## Planning and Access Committee

Agenda item: 4

<b>APPLICATION NUMBER:</b>	ECU00004966 (Scottish Government Energy Consents Unit reference) EXT/2025/0008
<b>APPLICANT:</b>	Glen Lednock Wind Farm Ltd
<b>LOCATION:</b>	Glen Lednock Windfarm approximately 8km Northwest of Comrie.
<b>PROPOSAL:</b>	Proposed windfarm comprising of up to 19 wind turbines, of which up to 16 are 200m to tip and up to 3 are 180m to tip, and associated infrastructure
<b>NATIONAL PARK WARD:</b>	Ward 2 Breadalbane & The Trossachs
<b>COMMUNITY COUNCIL AREA</b>	Balquidder Lochearnhead and Strathyre St Fillans Killin
<b>CASE OFFICER:</b>	Name: Jennifer Paton Tel:01389727738 E-mail: <a href="mailto:jennifer.paton@lochlomond-trossachs.org">jennifer.paton@lochlomond-trossachs.org</a>

- 2.1. That Members: **APPROVE** the contents of this report as its submission to the Scottish Government Energy Consents Unit, as the National Park Authority’s consultation response on the application. The response concludes that the National Park Authority objects to the proposal for the following reasons:
  - i. The proposal would introduce a step change to the existing pattern of windfarm development close to the National Park due

Figure 2: Site location showing proposed access, and turbine development area with National Park boundary in yellow (Extract from EIA Figure 2.5)

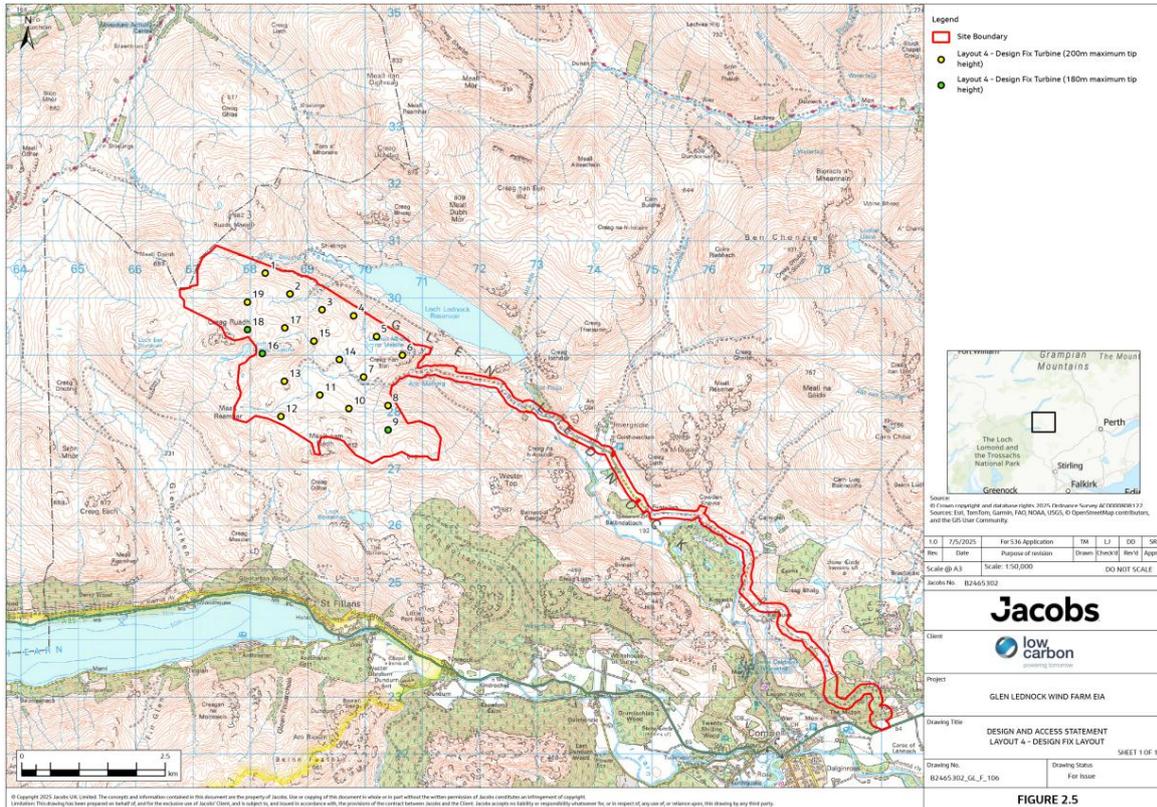
3.4. Figure 2 above highlights the proximity of the turbines to the National Park Boundary. In addition, the proposal is situated approximately 3km from the River Earn Comrie to St Fillan’s National Scenic Area (NSA). The closest Scheduled Ancient Monument to the application site within the National Park boundary is Dundurn Fort, on St Fillans Hill which lies approximately 4km south of the application site.

EIAR Vol 4 - Figure 6.11 Visual receptors and ZTV (bare earth)

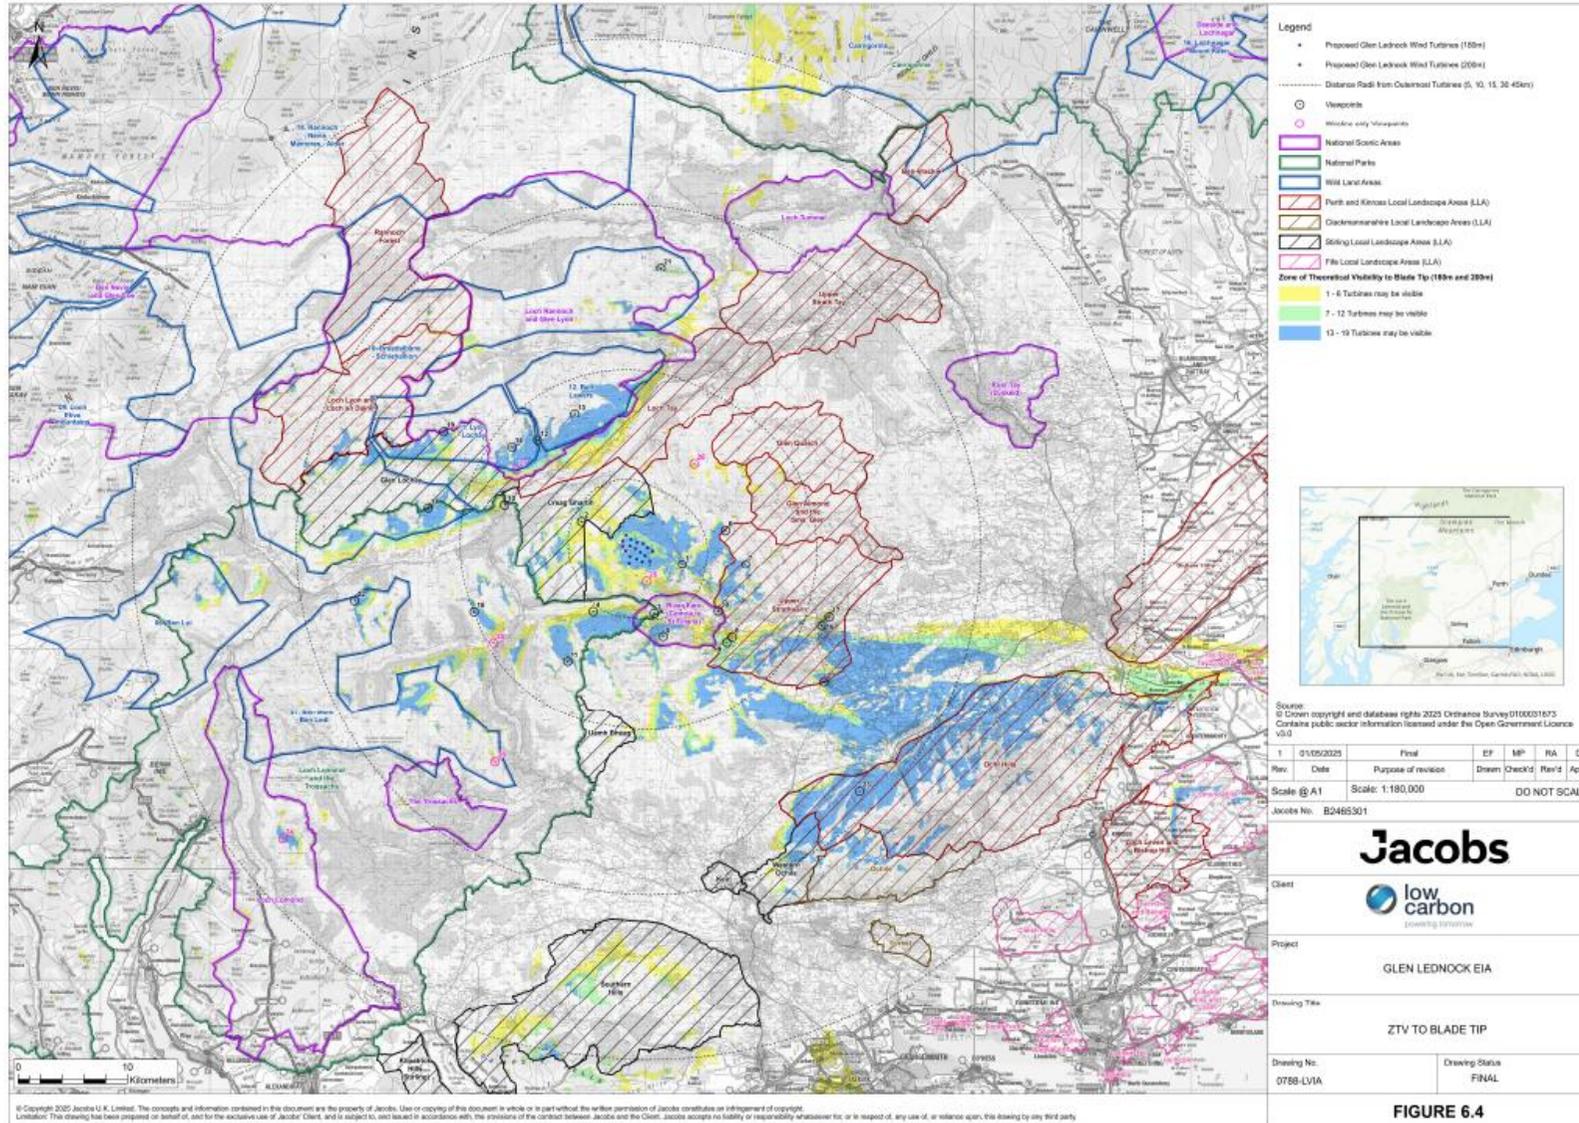
- 7.13. The LVIA ZTV's (Appendix 1) show theoretical visibility of the proposed development across some key high points, elevated areas and some lower elevated areas of the Breadalbane area within the northeastern part of the National Park. Key viewpoints (VP's) are shown at Appendix 2.

7.31. The Zone of Theoretical Visibility (ZTV) analysis presented within the LVIA shows widespread theoretical visibility of the proposed development within 25km across the north and eastern area of the National Park and the Comrie to St Fillans National Scenic Area (NSA).

*EIAR Vol 5 - LVIA Figure Viewpoint 11 –Ben Vorlich from summit at 974.5 m AOD*

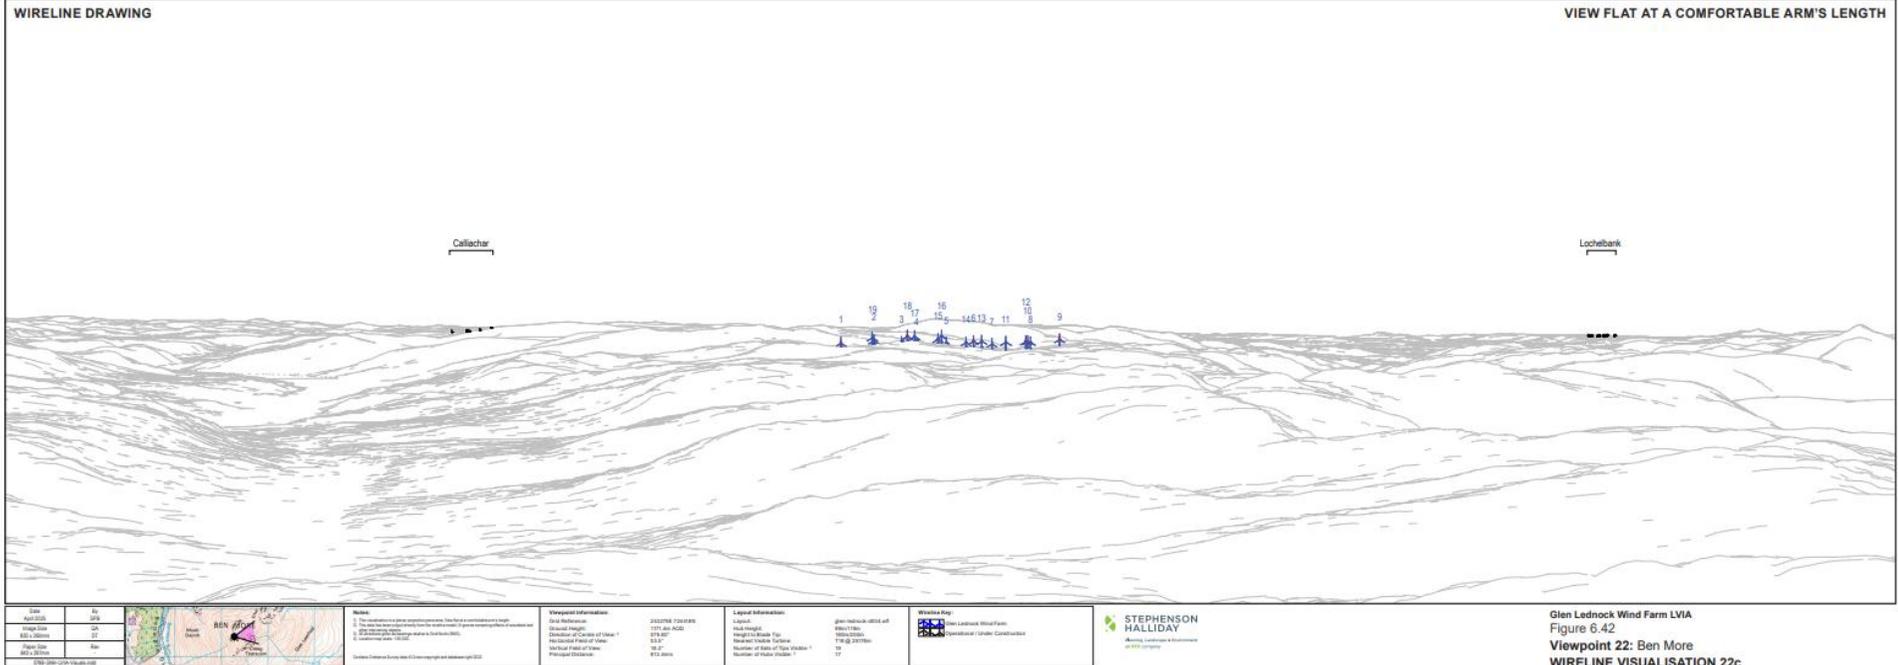
- 7.14. From Ben Vorlich (VP11), there would be a notably larger scale change than the medium/small scale reported. Although there is some evidence of man-made influences including windfarms from this viewpoint and Meall an t-Seallaidh, (VP15) these are seen in successive views away from the site of the proposed development and which forms part of the wider undeveloped upland plateau and helps to contribute to qualities of tranquillity experienced from summits and glens.

7.23. Night-time Visibility: Night-time viewpoints within the National Park are provided for Viewpoint 4: Loch Earn south side and Viewpoint 11 Ben Vorlich. NatureScot visited the viewpoint at Ben Vorlich at night and has advised that the manipulated day time photography (used to show night-time effects) does not represent the baseline as it would be experienced in reality and it is not fit for purpose. They have identified that that some other sources of artificial light are present at lower elevations in the base line which is not shown in the manipulated day time visual within the LVIA. It is therefore not a true representation of the nighttime effects from this proposal at Ben Vorlich.

EIAR Vol 5 - LVIA Figure Viewpoint 18 –Bheinn Bhreac summit at 795.1 m AOD

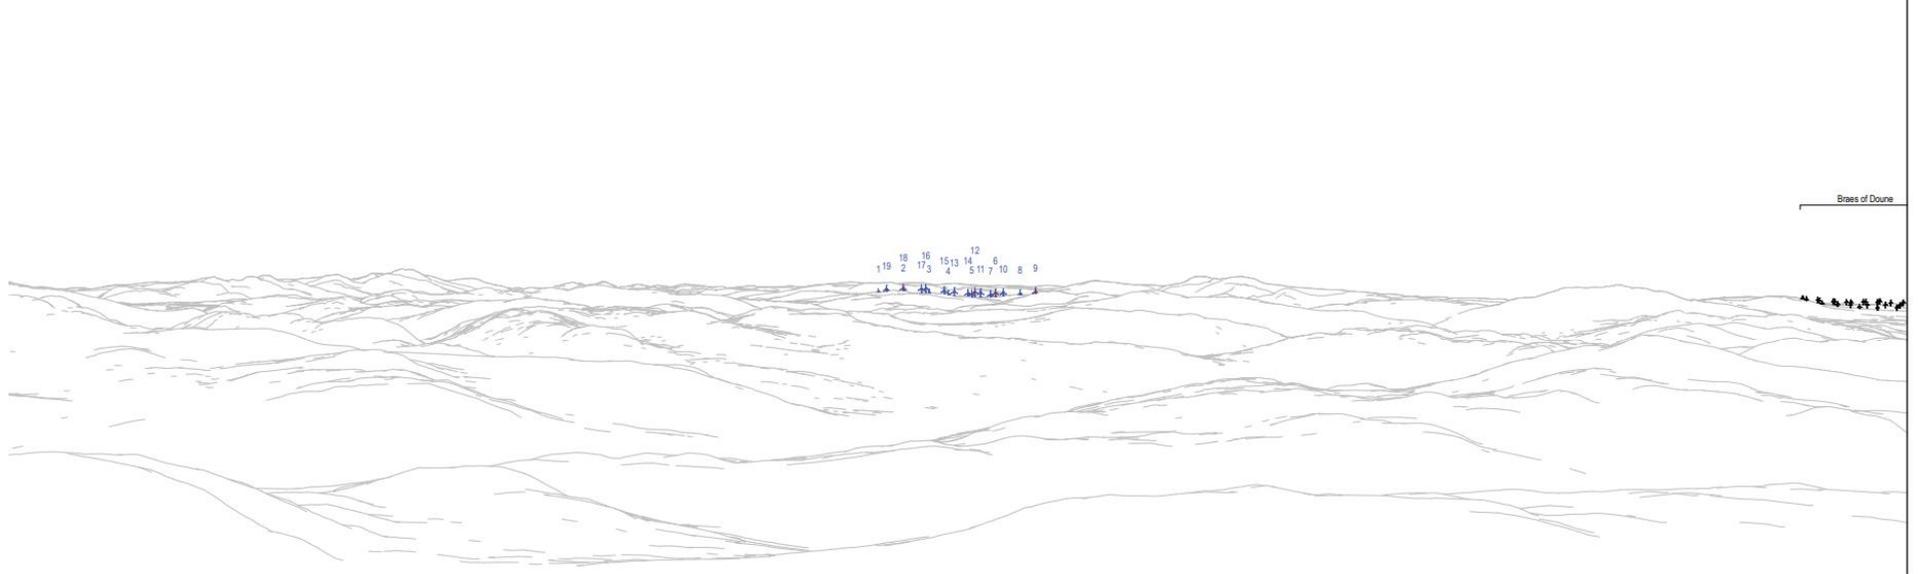
- Viewpoint 4: Loch Earn south side
- Viewpoint 11: Ben Vorlich
- Viewpoint 15: Meall an t-Seallaidh
- Viewpoint 18: Bheinn Bhreac

7.22. The proposed Glen Lednock windfarm would introduce a dominant man-made element in close proximity to the National Park boundary. Located within the Summits and Plateaux-Tayside landscape character type, this backdrops Loch Earn and the proposal would be evident south of Lochearn, from Ben Vorlich, Meall an t-Seallaidh and Bheinn Bhreac.

EIAR Vol 4 Figure 6.2 Cumulative Location Plan

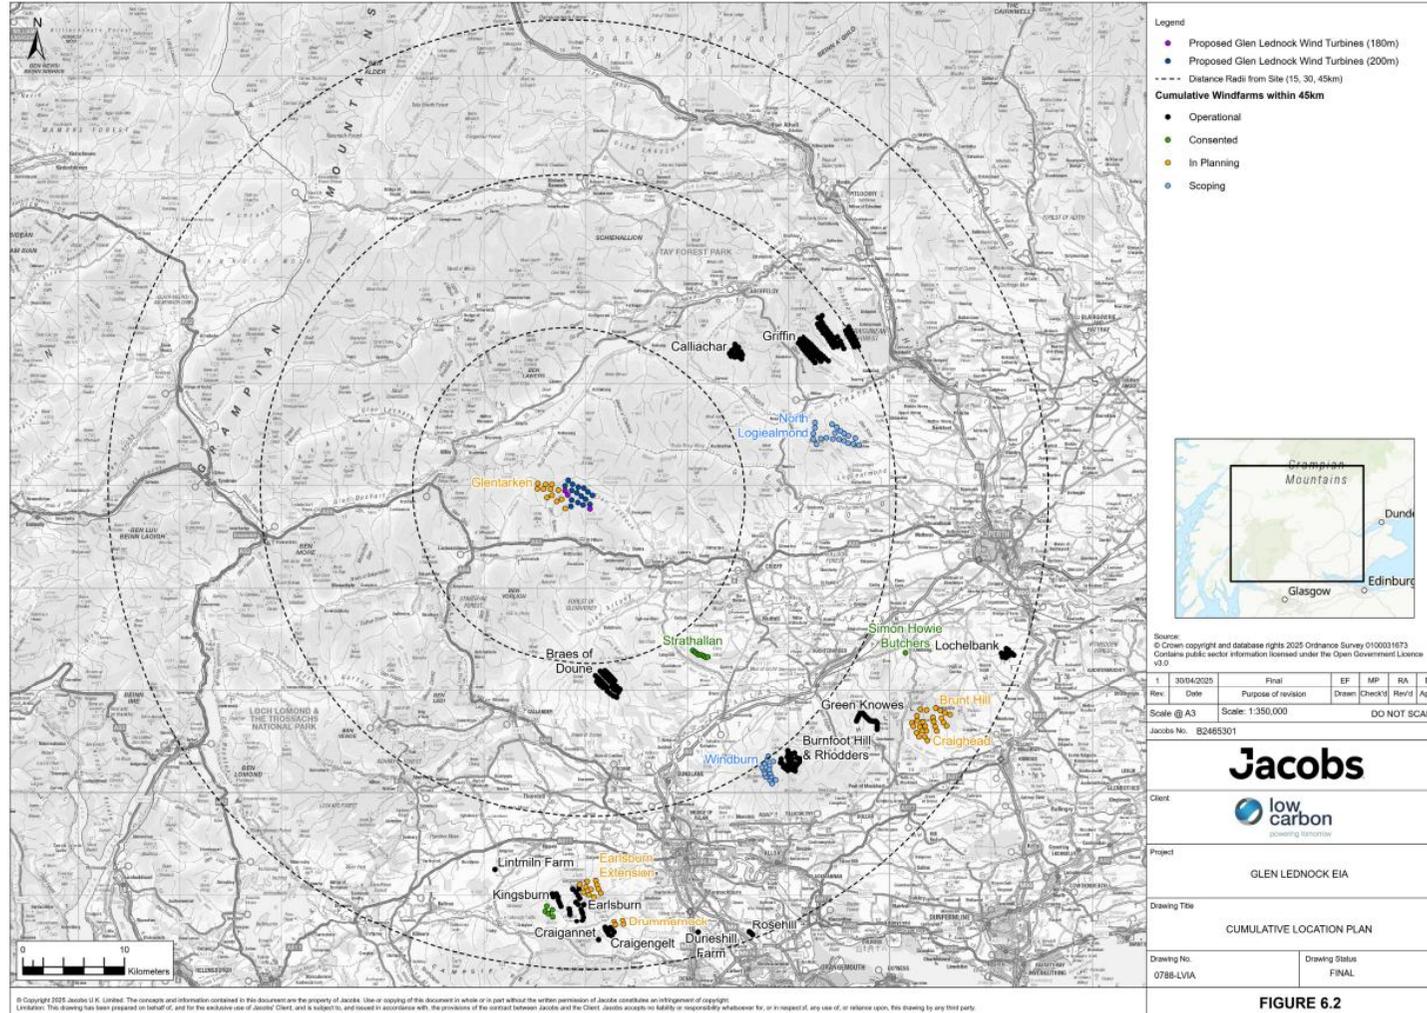
7.28. The ‘Cumulative Location Plan’ at Appendix 3 shows the location of the proposed development in context with other windfarms. The proposed Glen Lednock turbines are shown in blue and the proposed Glentarken wind turbines in yellow. Existing operational windfarms are shown as black and consented windfarms are shown in green.

7.29. The nearest operational windfarm on this side of the National Park is Brae of Doune approximately 15km to the south. Griffin lies approximately 18.5km to the northeast and Calliachar approximately 16.5 km to the northeast. Those turbines range in height from 109.8m – 124m which are substantially smaller than the proposed turbines and distant from the National Park by comparison.
